# LAYTON TREE CONSULTING, LLC

## TREES & CONSTRUCTION MEMO

To: Paul Bosveld  
From: Bob Layton  
CC: Heather Crain, Matt Wittman  
Date: March 31, 2022  
Re: Tree Protection at 38XX W Mercer Way

Photo Documentation

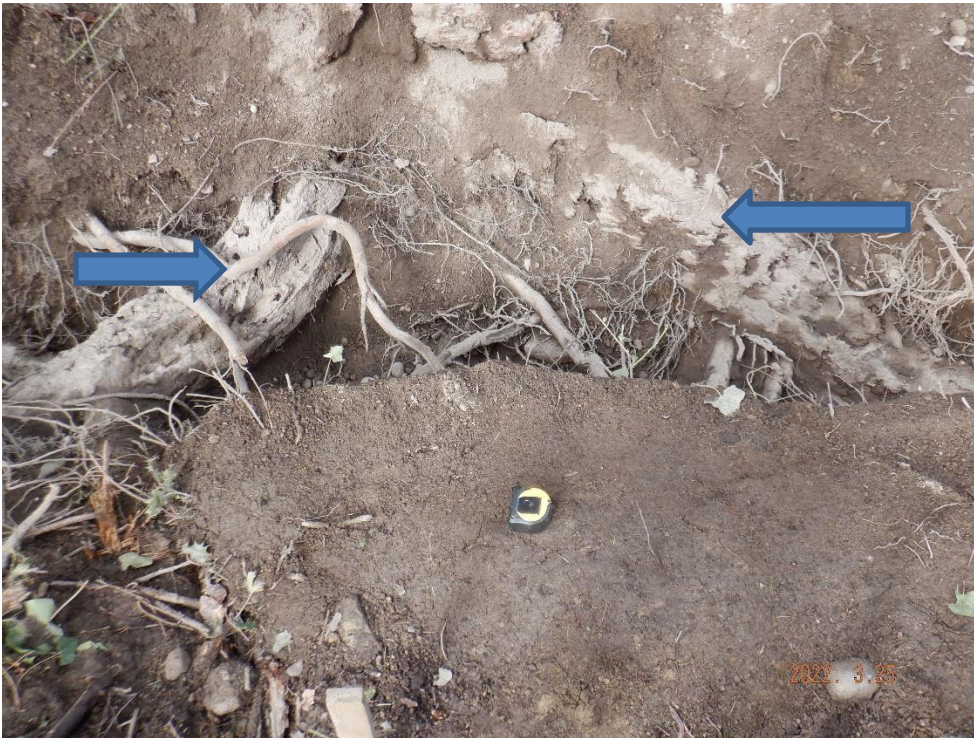
Trees requiring the most attention include Tree #23 and the neighboring Trees B, C and D. These are closest to the proposed site work. The buttress root locations of Tree #23 were air-excavated. See pictures below. The concrete footing proposed directly 4-feet east of the trunk face sits between the two exposed buttress roots which radiate away from the footing location. The footing may need to be slightly shifted north to avoid the south buttress root.

A trench was also air-excavated at 14 ½-feet south of Tree #23 at the proposed cut in grade for the new house. Only one 2-inch diameter root was exposed. See picture below. This root can be cut at the excavation limit without having any impact on the health or stability of the tree.

Root crown of Tree #23, 10-inch diameter buttress on left, 12-inch diameter buttress on right (arrows).

Exposed roots east of #23, proposed footing locations (arrows), north buttress root runs farthest west along edge of trench and would not be impacted

Decayed root pictured above at edge of proposed footing, can be pruned away

Trench air-excavated south of #23 at proposed cut in grade

TREE #23  
PROTECTION PLAN

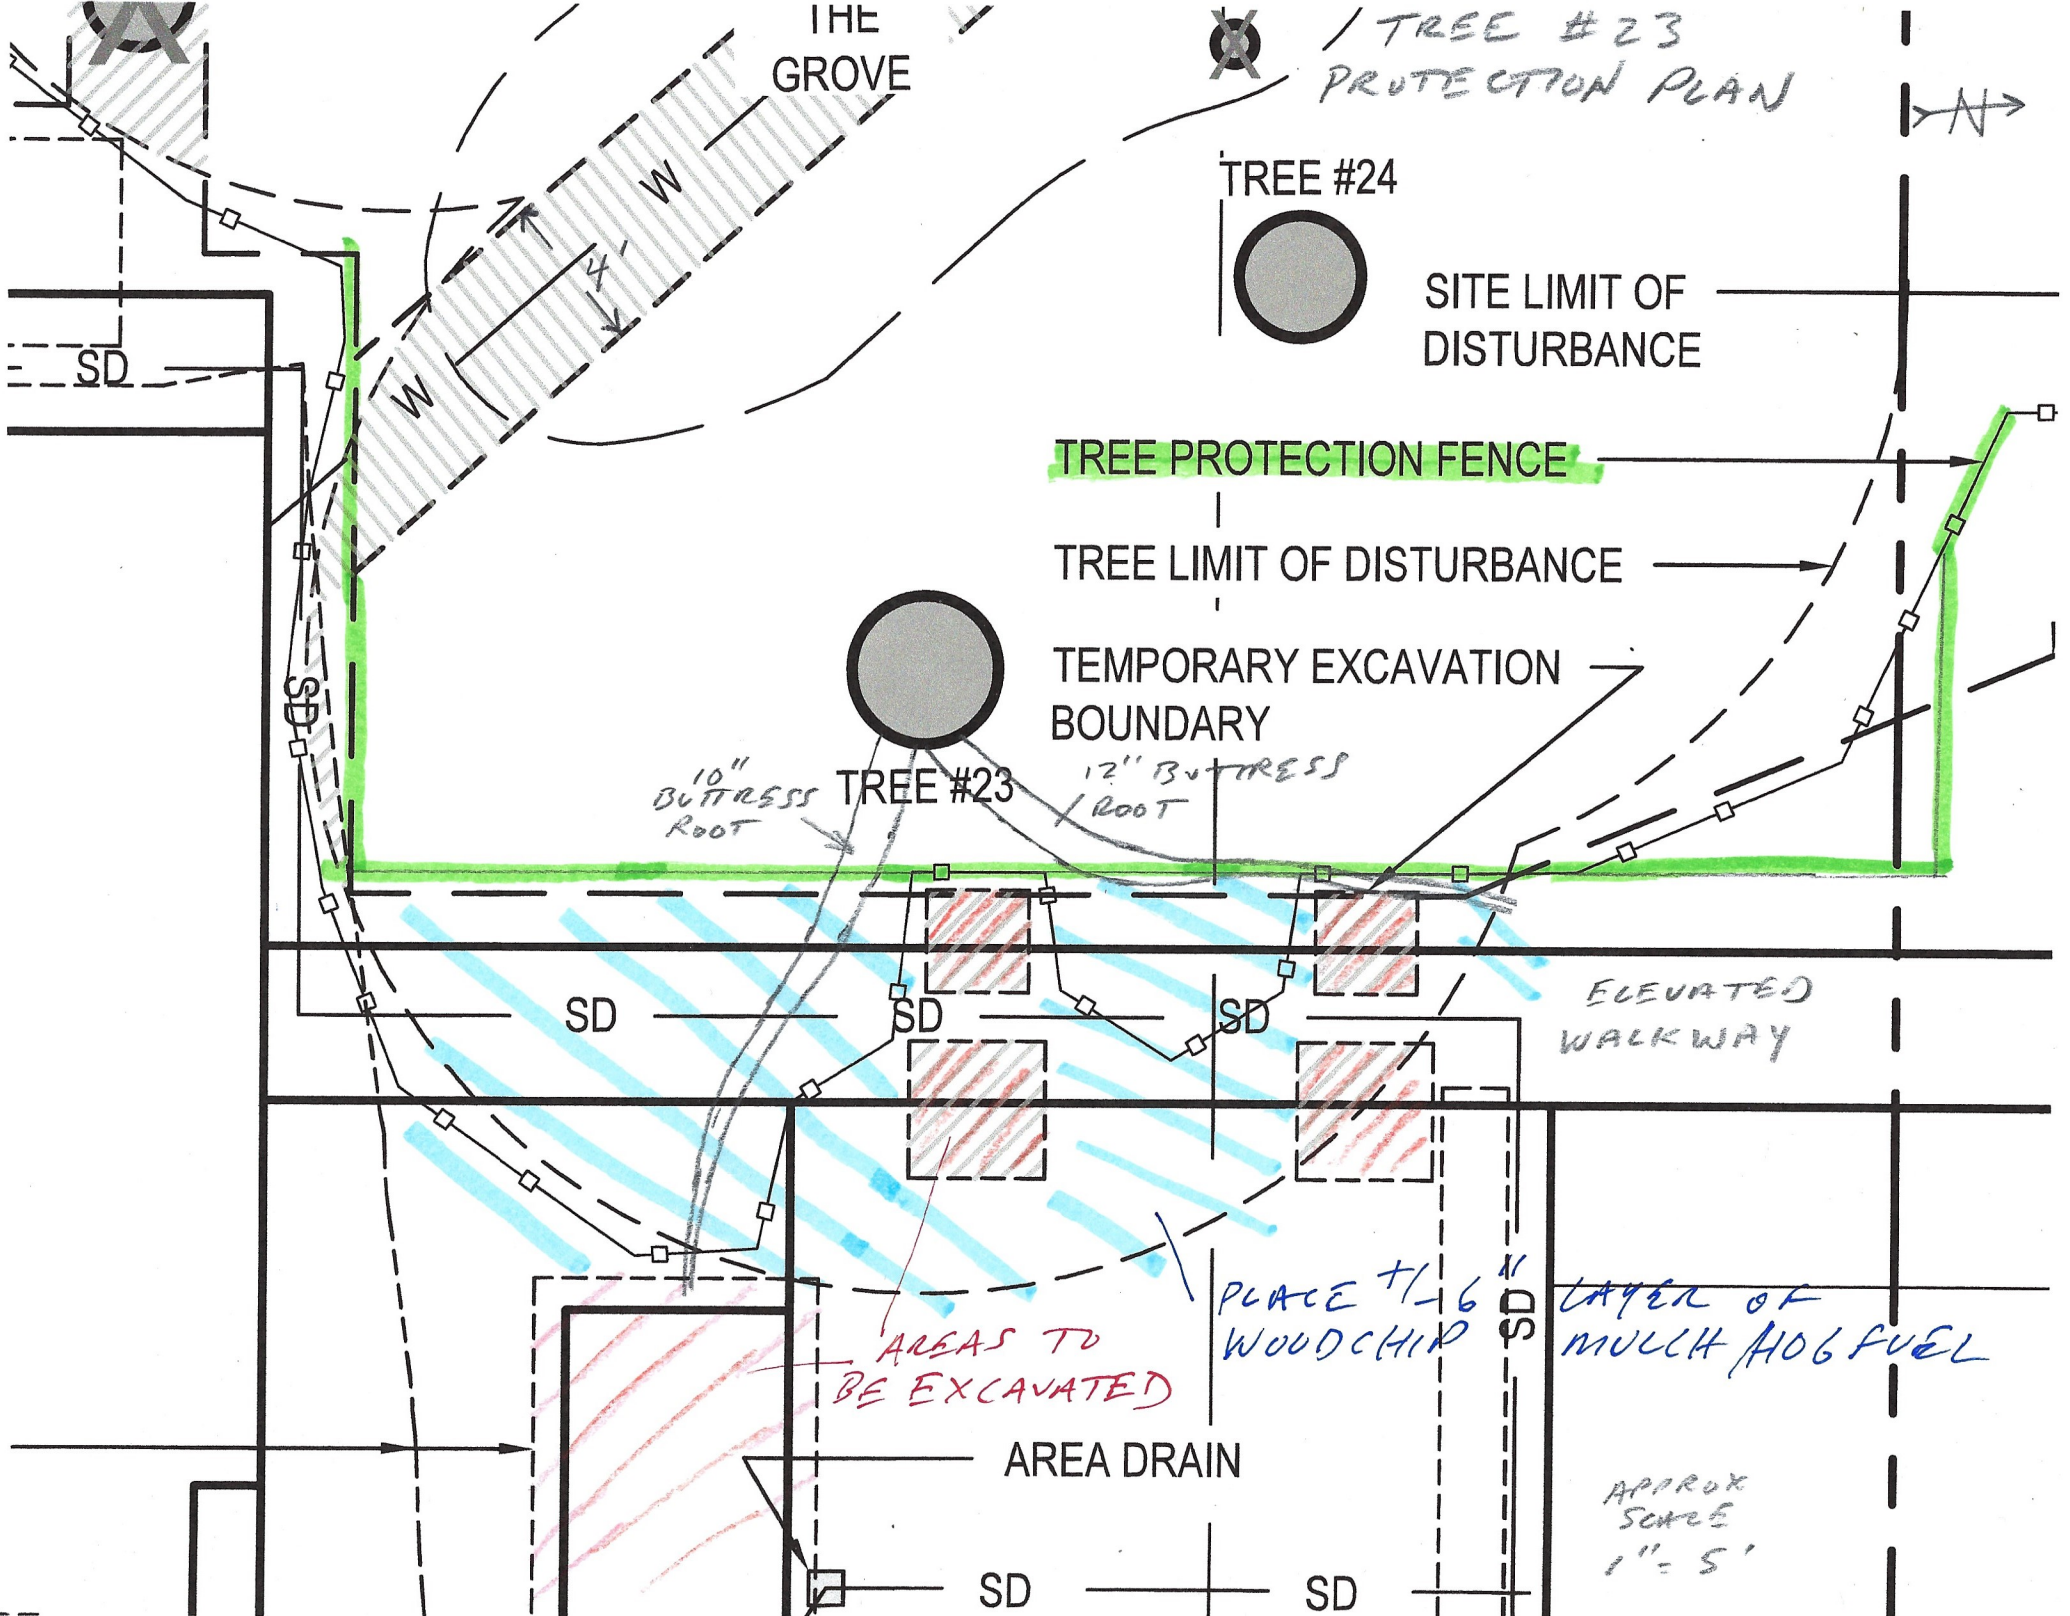
It is the intent of the owner to retain Tree #23. 5-feet of clearance between Tree #23 and the proposed improvements is not possible, given the size constraints of the area to be developed. One of concrete footings necessary for the garage and elevated walkway construction has to be within a proximity of the tree, which will not afford the 5-foot clearance. The recommended location of tree protection fencing is shown on the attached map.

AREAS TO  
BE EXCAVATED

PLACE +/- 6"  
WOODCHIP

# WATERLINE PLAN

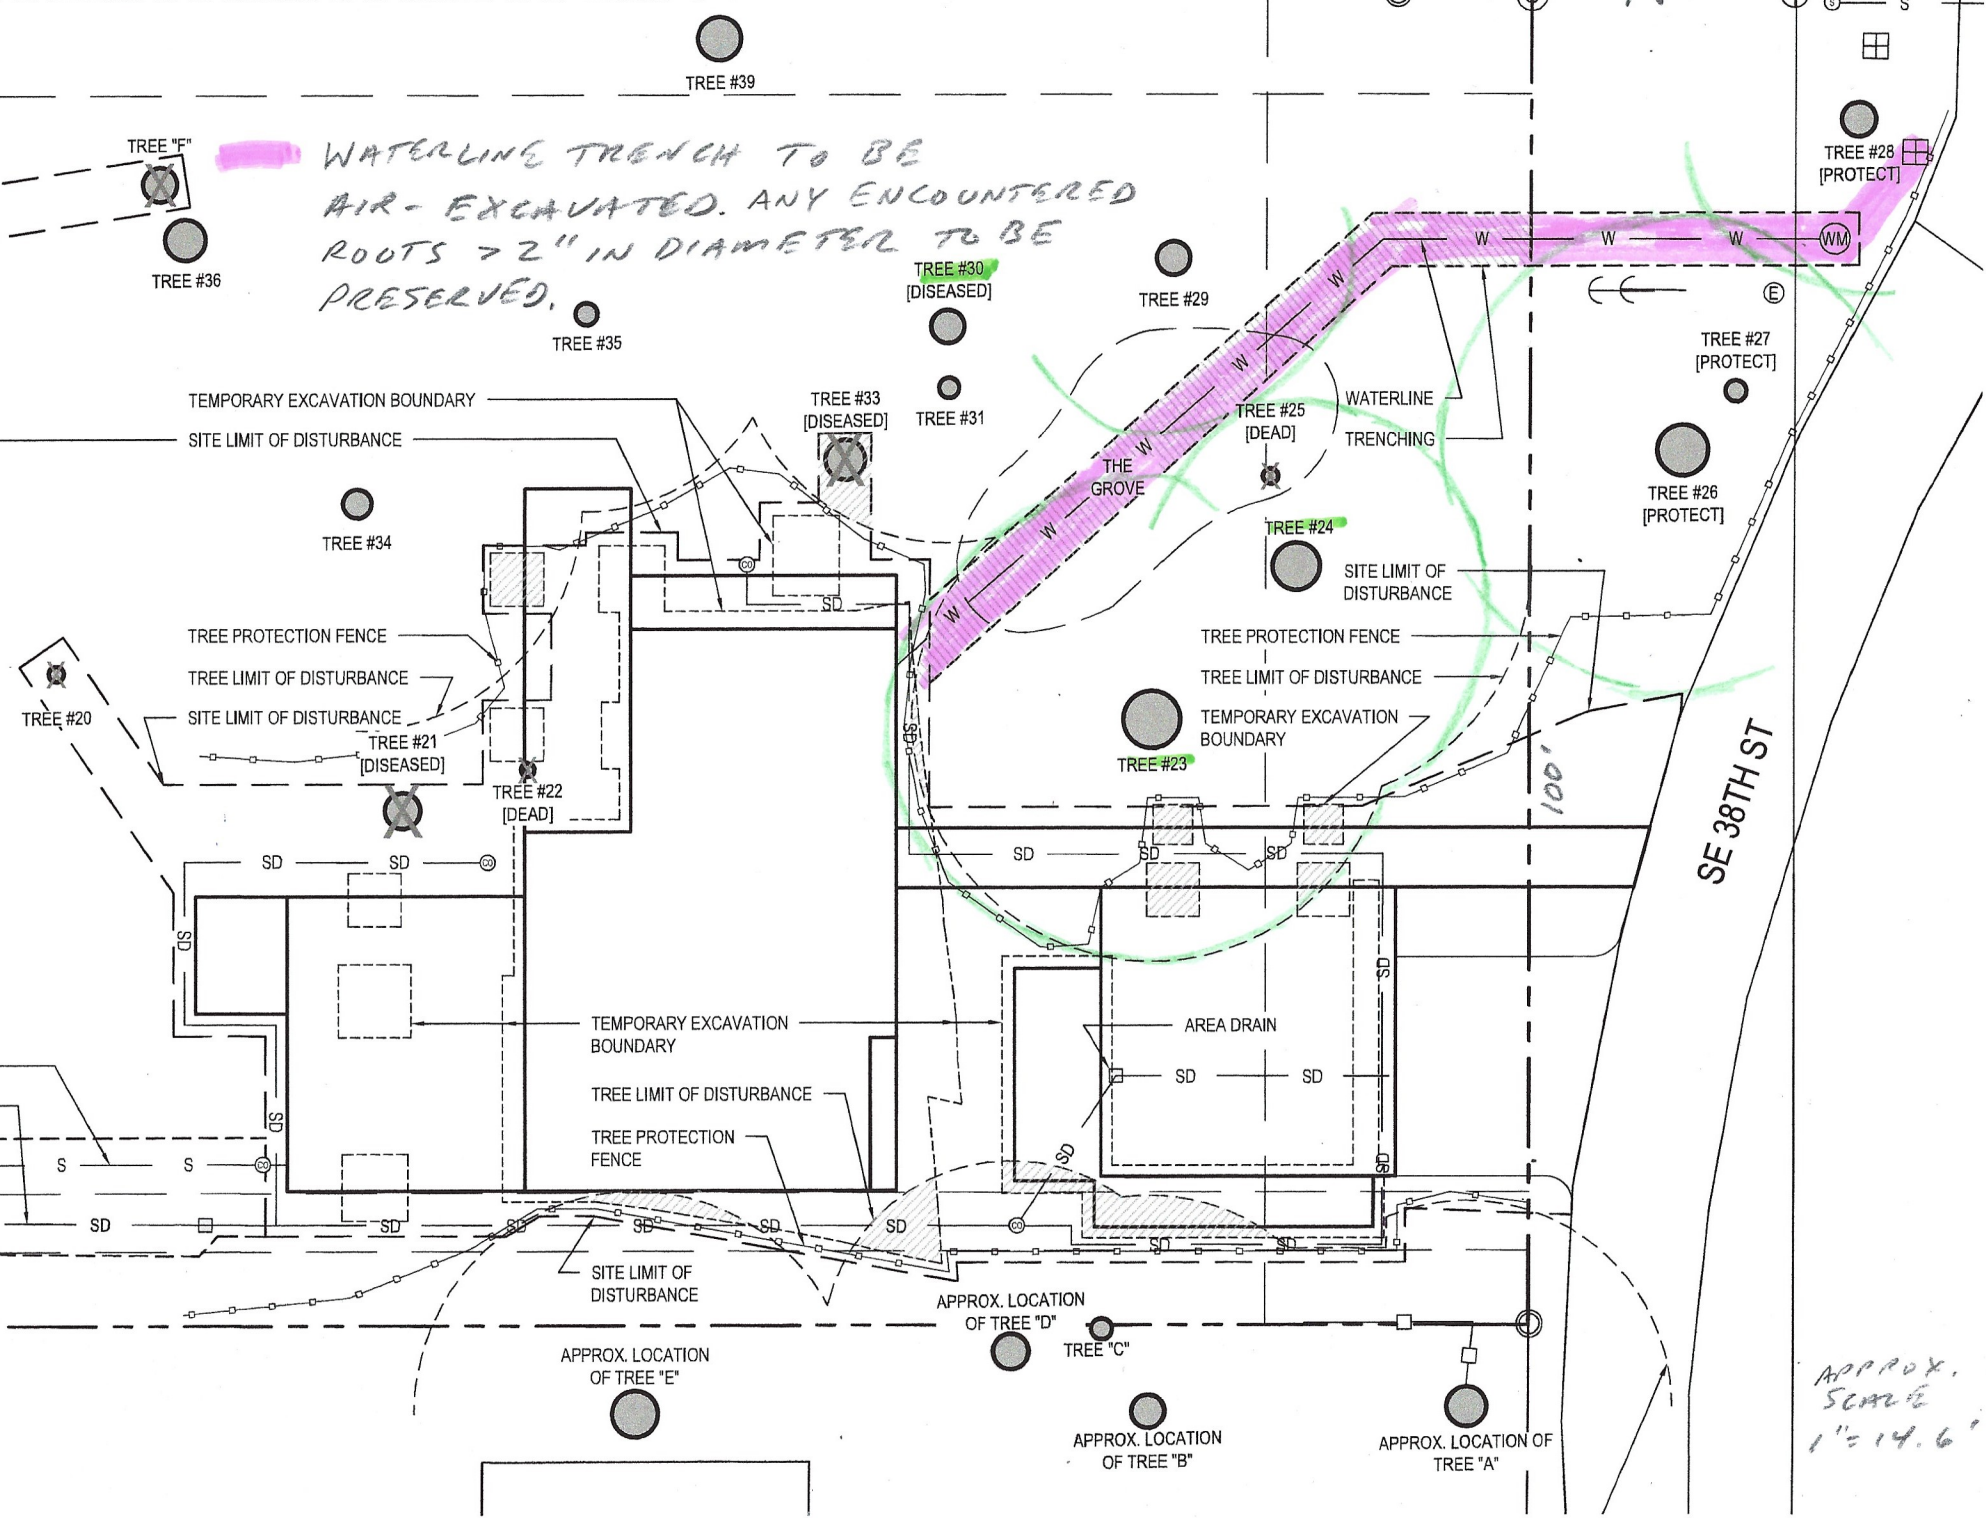
Given the number of exceptional trees to be retained within the vicinity of the water line utility, it is not possible to stay at least 12-feet away from all exceptional trees. The location of the trench will ultimately be field-located to be as far from exceptional trees as possible. The entire length of the water line trench will be air-excavated. All roots greater than 2-inches in diameter will be preserved and the utility/pipe routed beneath them. The trench location on the attached map is shown as 4-feet in width. Realistically, the trench would only need to be a foot to a foot and a half wide to install the plastic waterline.

WATERLINE TRENCH TO BE AIR-EXCAVATED. ANY ENCOUNTERED ROOTS > 2" IN DIAMETER TO BE PRESERVED.

# SOUTH UTILITY PLAN

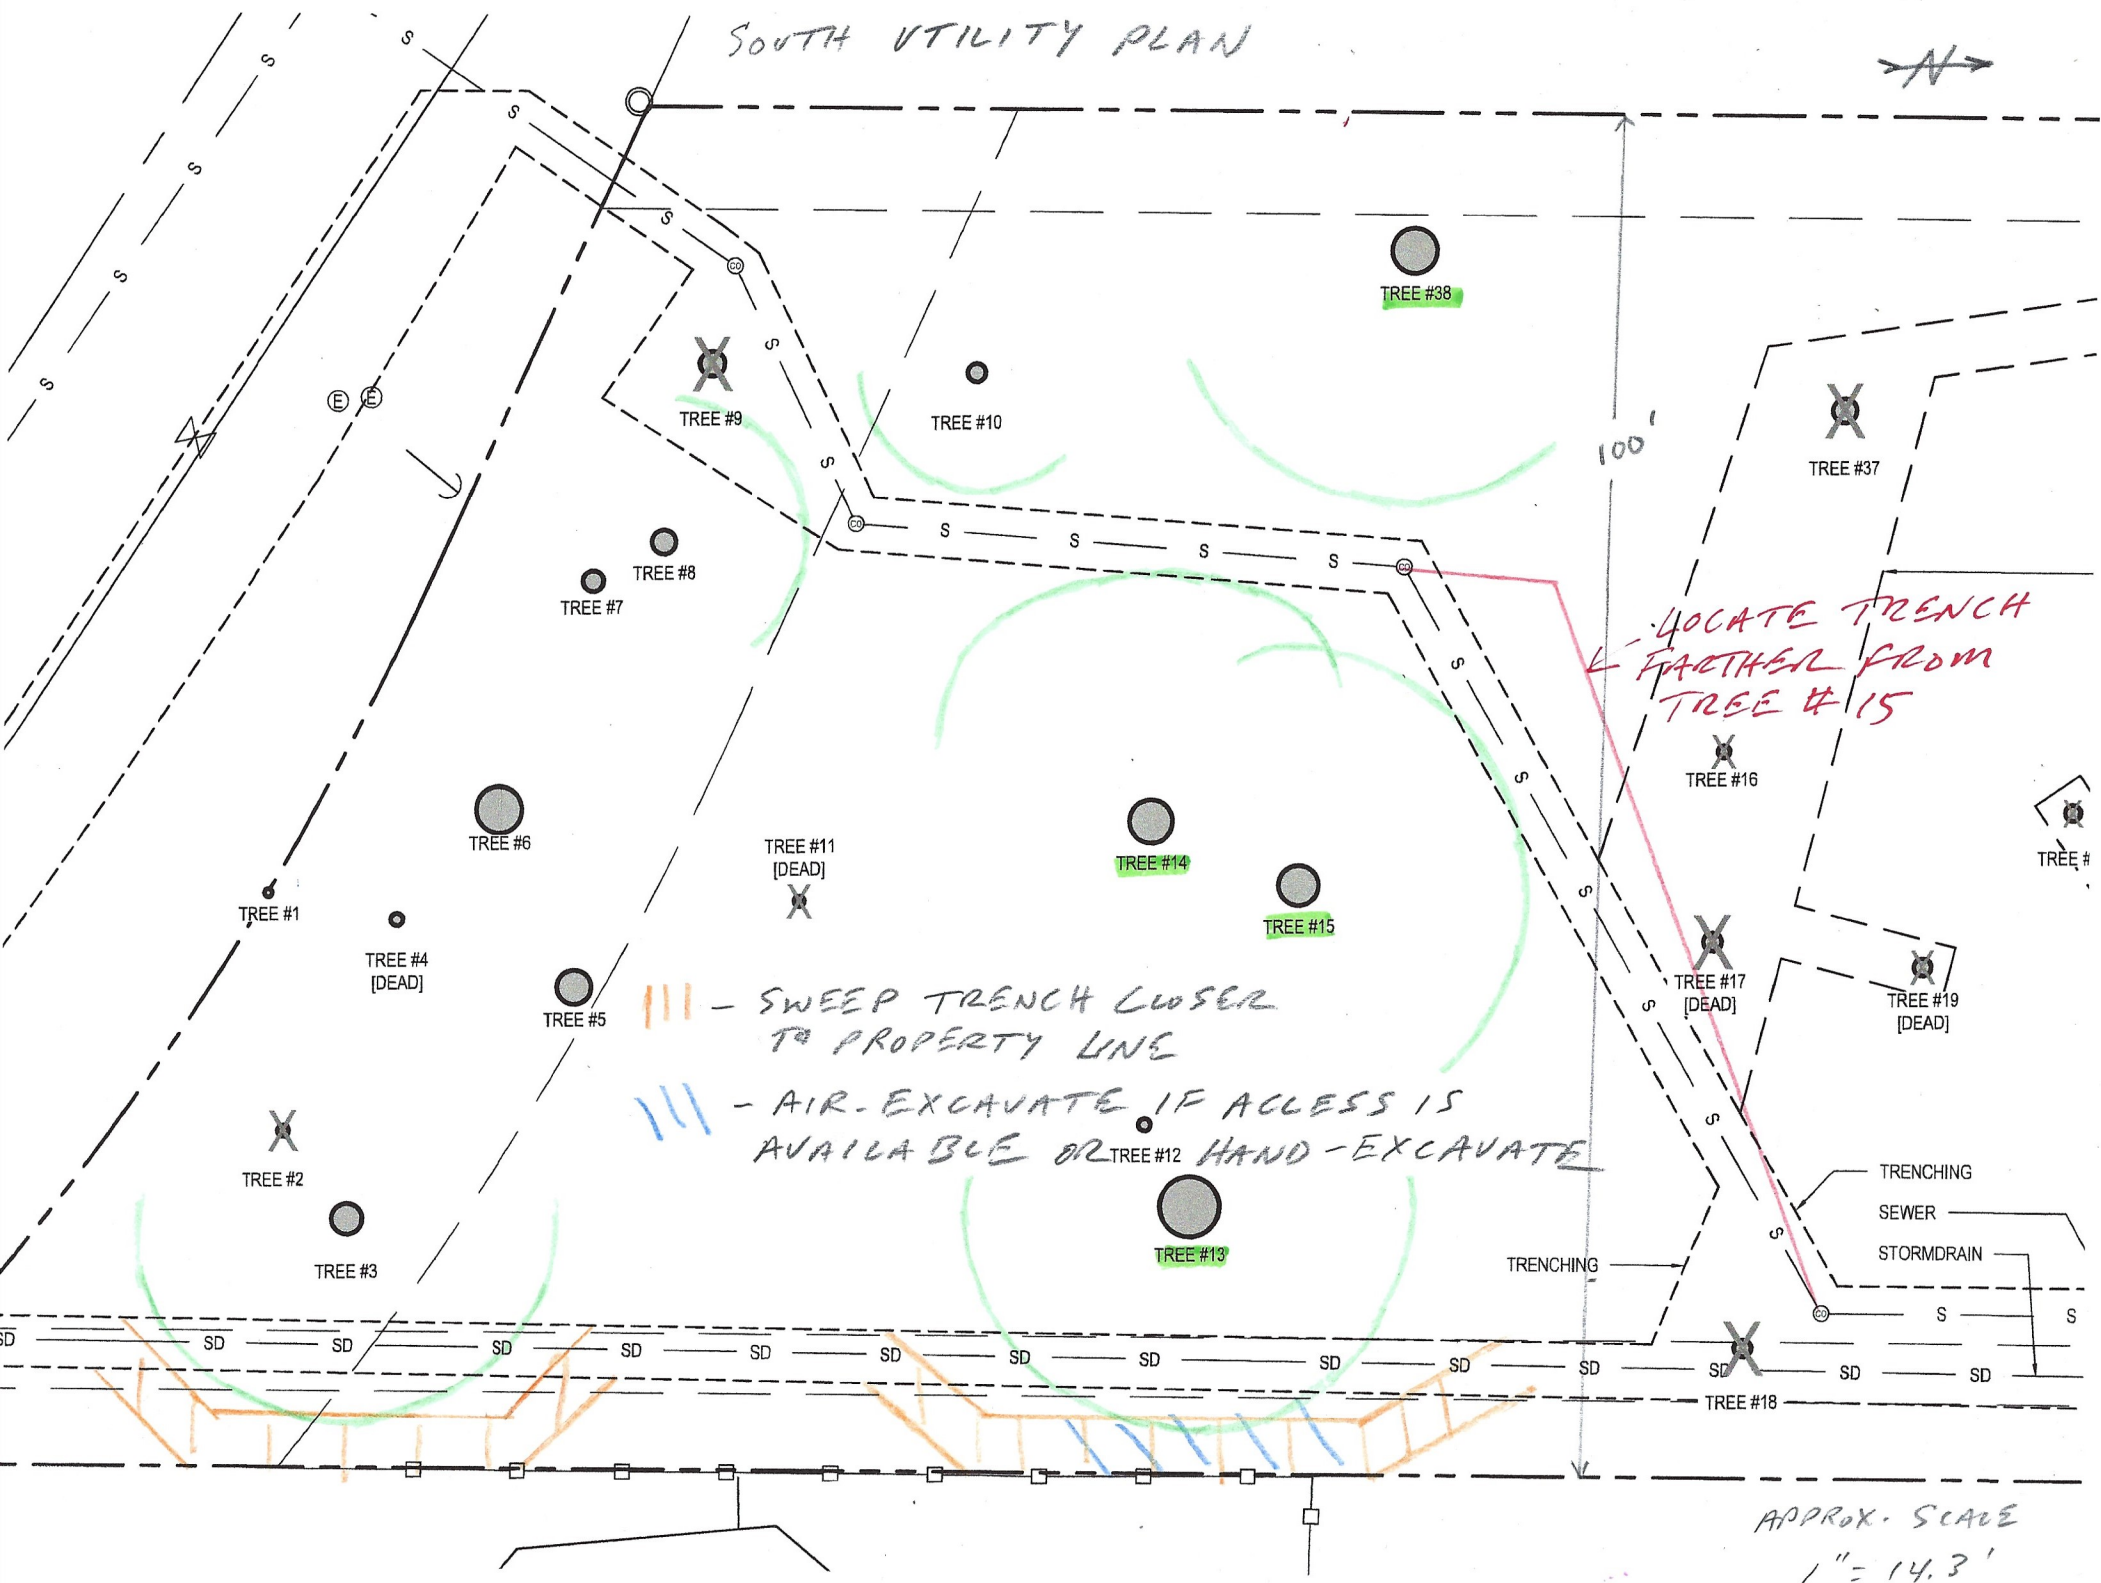
The sewer utility has been designed to avoid the driplines of adjacent trees. The storm drain utility on the south perimeter shall be moved closer to the property line to the farthest extent allowable to reduce the impact to Tree #13 and Tree #3. See the attached copy of the site plan. Slightly move trench north away from Tree #15. The majority of trenching can be accomplished with a tracked mini-excavator. Air-excavate adjacent to Tree #13 if access available or hand-excavate to preserve any roots greater than 2-inches in diameter.

LOCATE TRENCH 1' FARTHER FROM TREE #15

||| - SWEEP TRENCH CLOSER TO PROPERTY LINE
||| - AIR-EXCAVATE IF ACCESS IS AVAILABLE OR TREE #12 HAND-EXCAVATE
